City of Portland, Maine - Building or Use Permit Application
 389 Congress Street, 04101 Tel: (207) 874-8703, Fax: (207) 874-8716

Permit No: 04-0132		Issue Date: FEB 27 2004	COL: 070 D005001
Location of Construction: 52 Bowdoin St	Owner Name: Spencer Alice B &	Owner Address: 52 Bowdoin St	Phone: CITY OF PORTLAND 07-797-3381
Business Name:	Contractor Name: Papi & Romano Builders, Inc	Contractor Address: PO Box 1079 Portland	Phone: 2077973381
Lessee/Buyer's Name	Phone:	Permit Type: Alterations - Dwellings	Zone: R-4

SPENCER RESIDENCE

STRUCTURAL REPAIRS

Proposed Partial Floor Plan

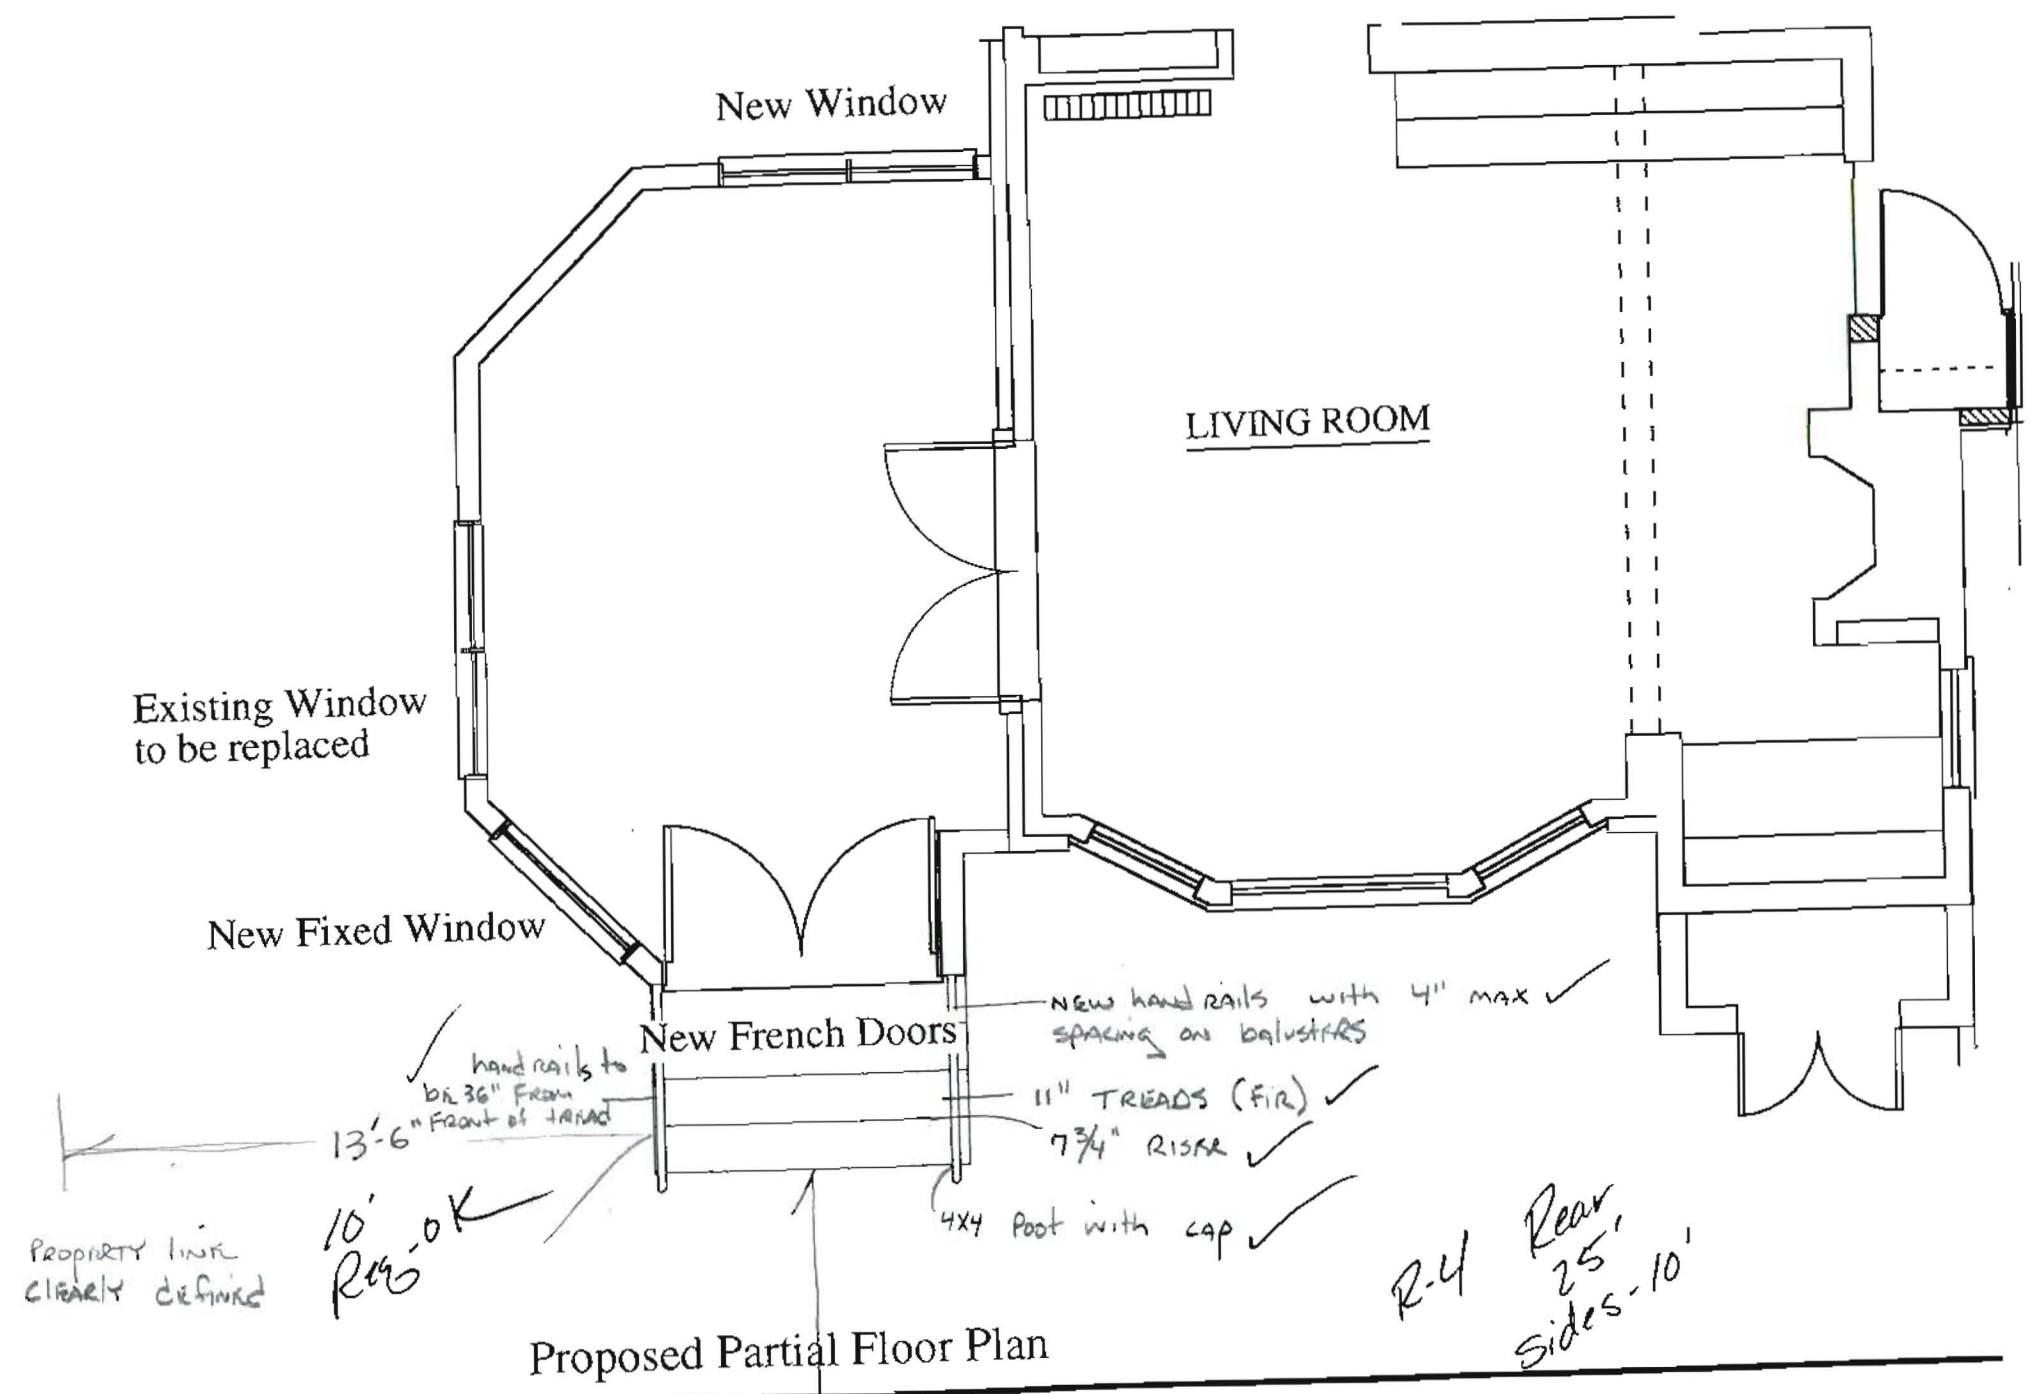
Comments: 2/19/2004-tmm: need stair details and plot plan - plans show adding new french doors - called builder left message
--

38' - OK
25' Req.

PROPERTY LINE CLEARLY DEFINED
